Cumberland County Subdivision and Land Development Review Report

Municipality:	<u>New Cumberland</u>	Surveyor/ Engineer:	<u>Michael C. D'Angelo P.L.S.</u>	Owner/ Developer:	<u>Harry and Suzy Grossman</u>
Plat Title:	<u>Harry and Suzy Grossman</u>				
Plat Status:	<u>P/Final</u>	Plat Type:	<u>S Subdivision</u>		
# of New Lots:	<u>2</u>	# of New Dwelling Units:	<u>0</u>	New Acreage Subdivided/Developed:	<u>1.17</u>
				Total Tract Acreage:	<u>1.17</u>
Zoning District:	<u>R-1</u>	Proposed Land Use:	<u>Residential</u>		
Date Received:	<u>3/26/2020</u>	County Review:	<u>4/15/2020</u>	Reviewed by:	<u>EG</u>
				Checked by:	<u></u>

FINAL TWO LOT SUBDIVISION PLAN
EXISTING CONDITIONS

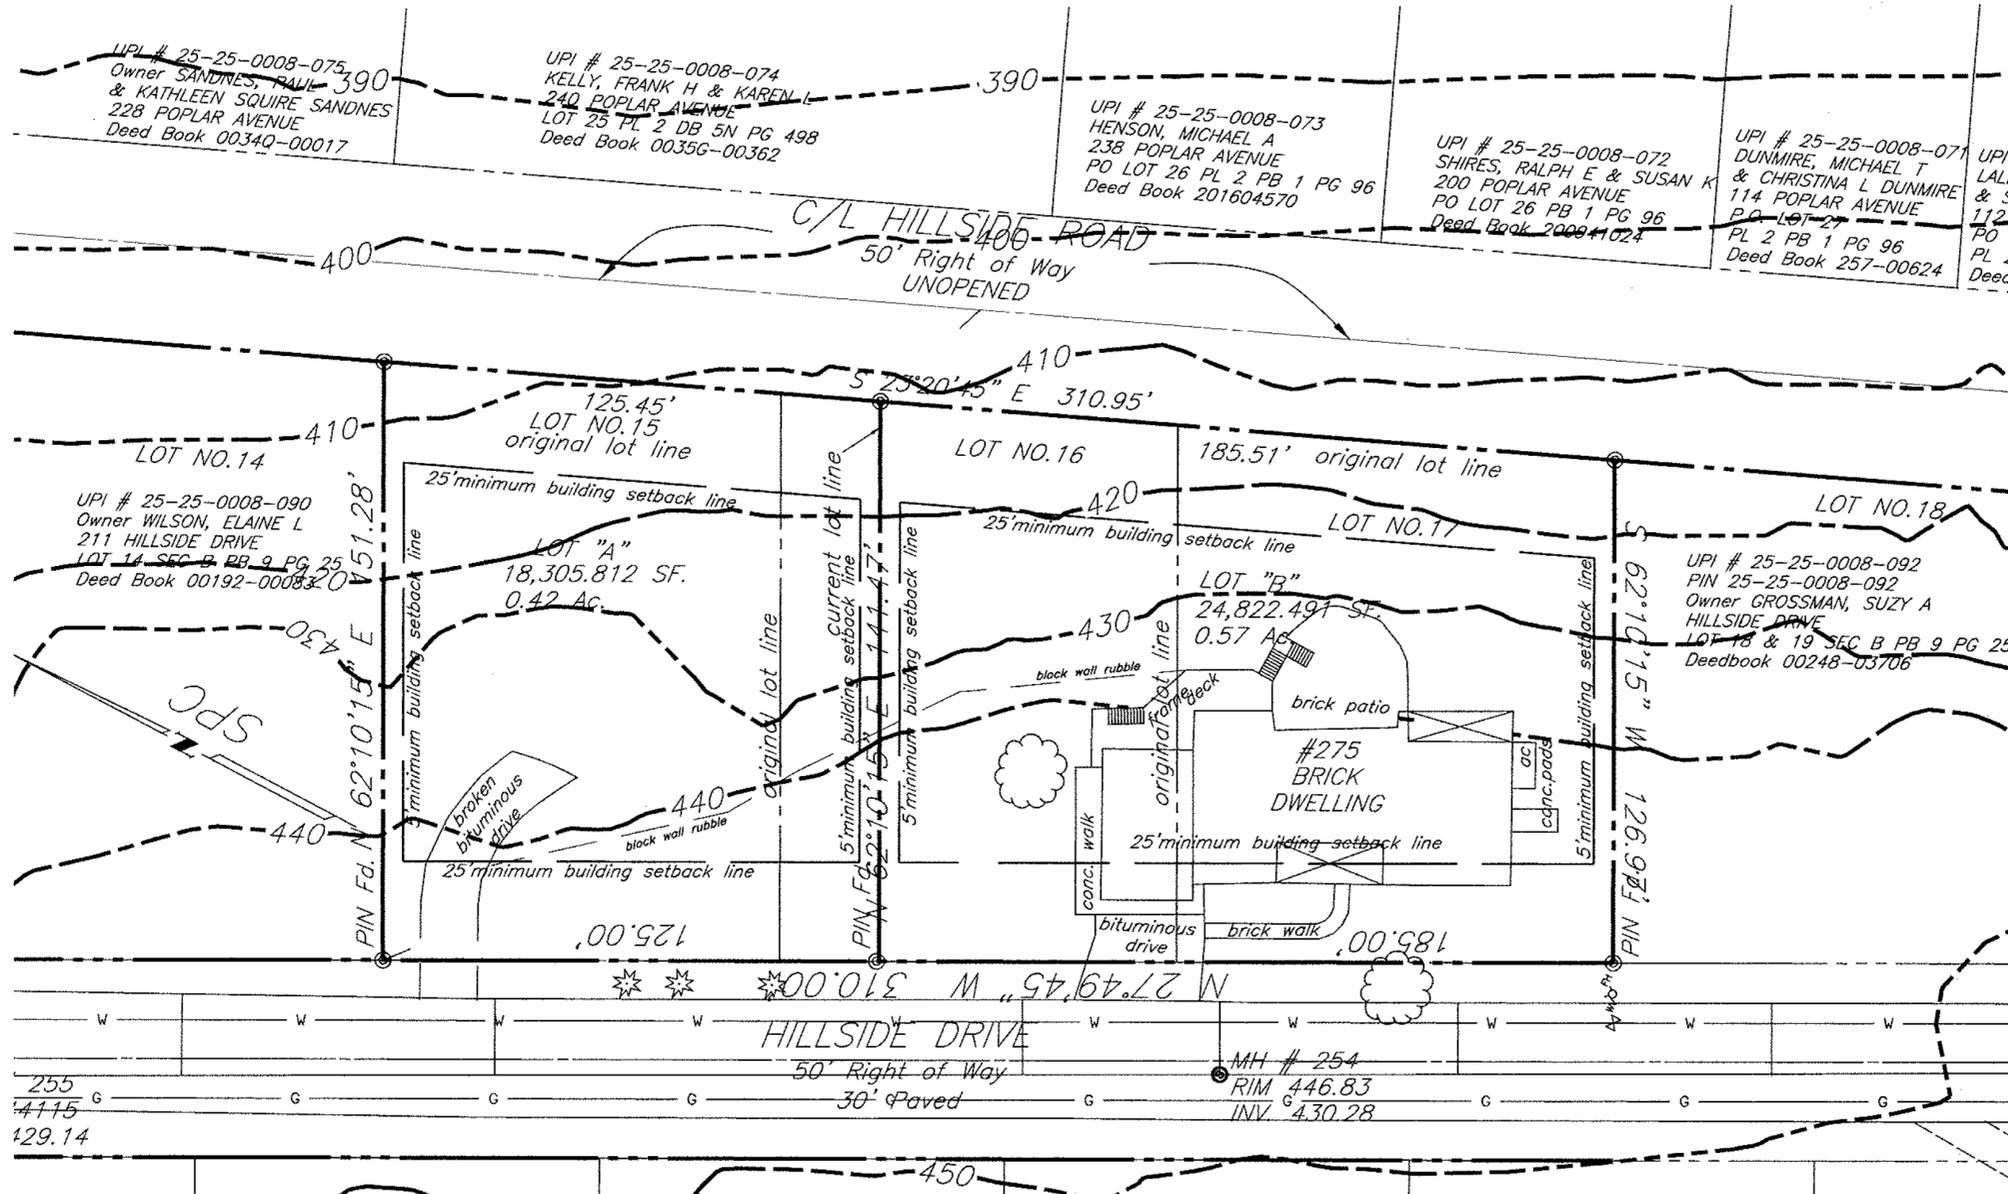
1. The plan should describe how the proposed lot coverage for AA is calculated to be 40%.
2. Will the impervious surfaces described in Lot A be demolished as a part of this plan? If the location of the driveway access to Lot A is to be changed, it should be detailed in the plan. (Zoning 1002, SLDO 502.6)

3. The Borough should verify that proposed Lots AA and BB no longer meet the definition and required setbacks for through or double frontage lots with respect to the unopened status of Hillside Road. (Zoning 1010.02, SLDO 505.2)
